***ADDENDUM # 001***

**Holy Trinity Catholic School  
60 Lorne Crescent  
Sarnia, Ontario**

**Site and Parking Lot Improvement Work**

**Project No. 651-CP1607**

DATE PLOTTED: 5/12/2016	DRAWN: SD	DRAWING No. A010
SCALE: AS NOTED	CHECKED: RW	
PROJECT No. 1601

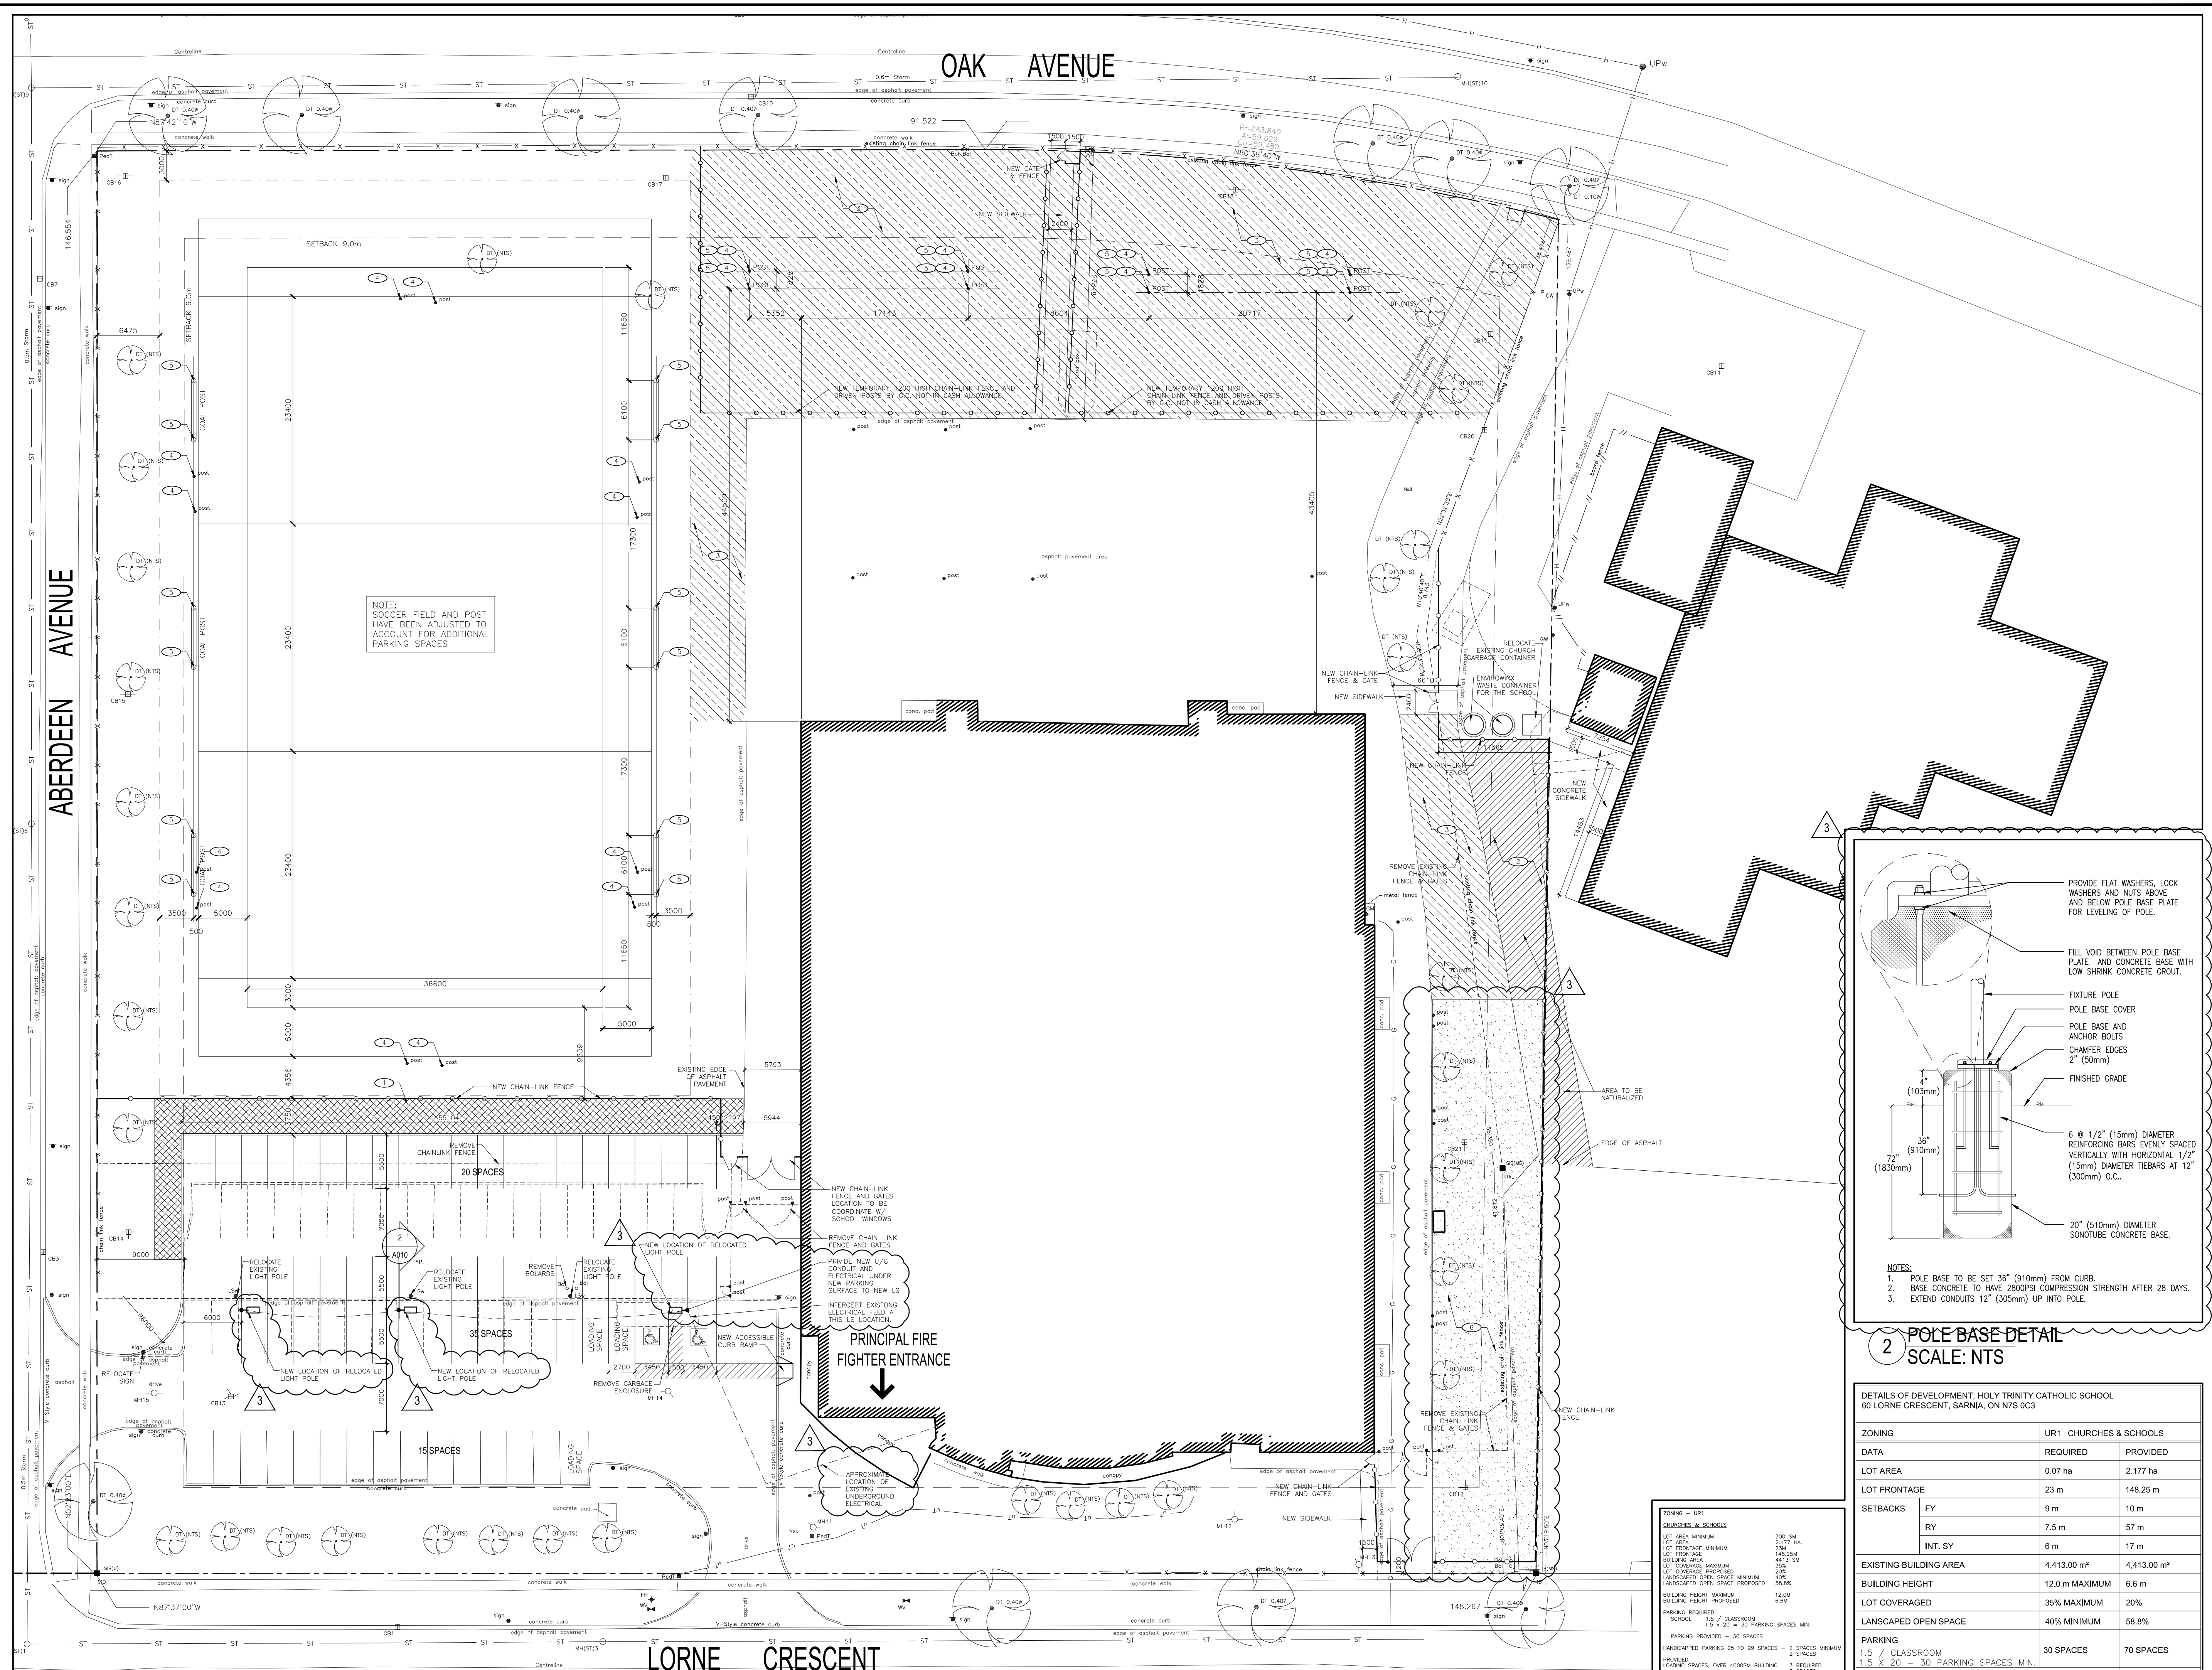
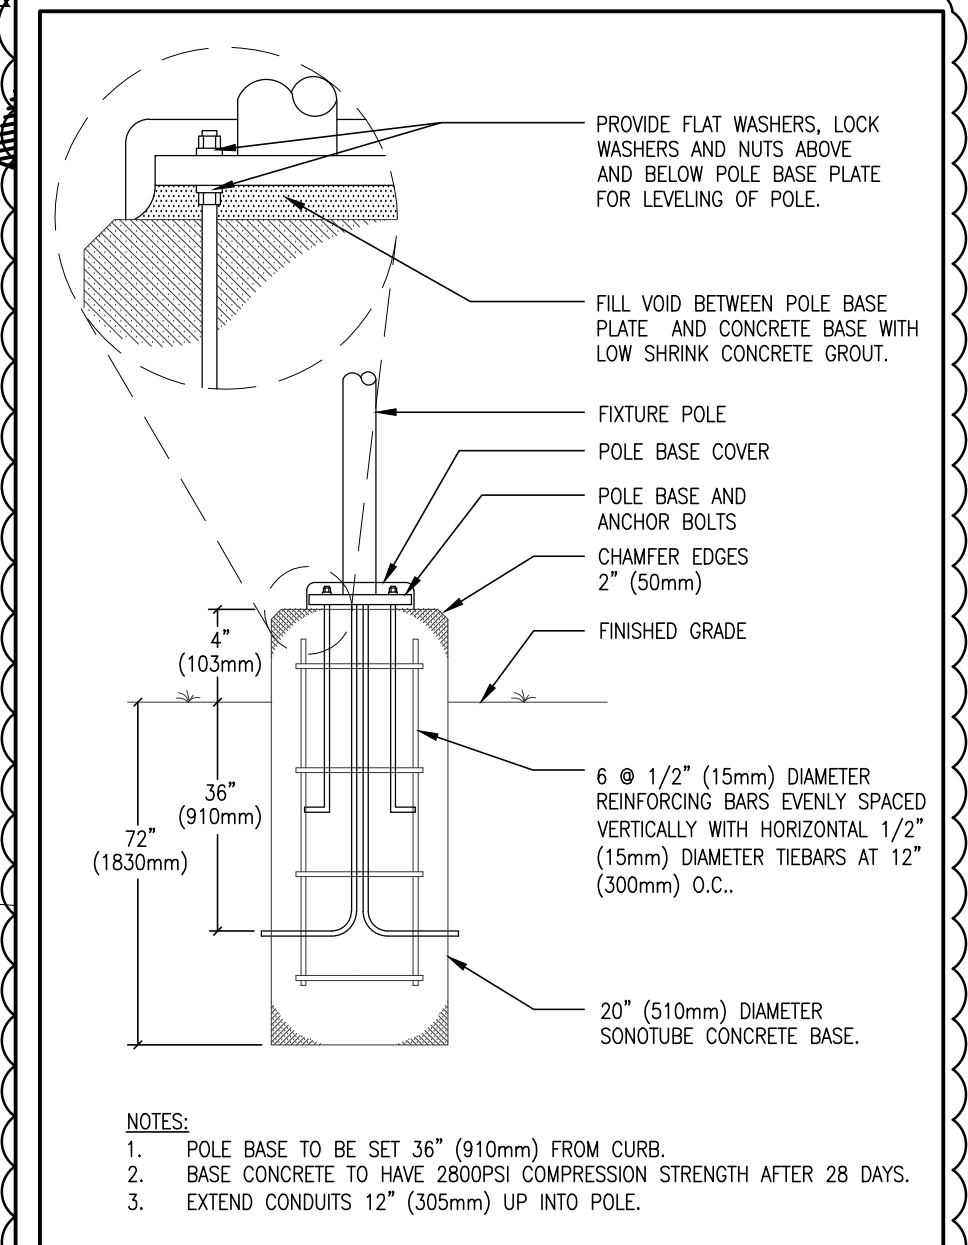
- a. Question: There are two light base drawings, one on the A010 and another on C-1, which one has precedence?  
Answer: The one indicated on C1 is the correct light base detail.

Revisions for Addendum #1 clouded and noted.
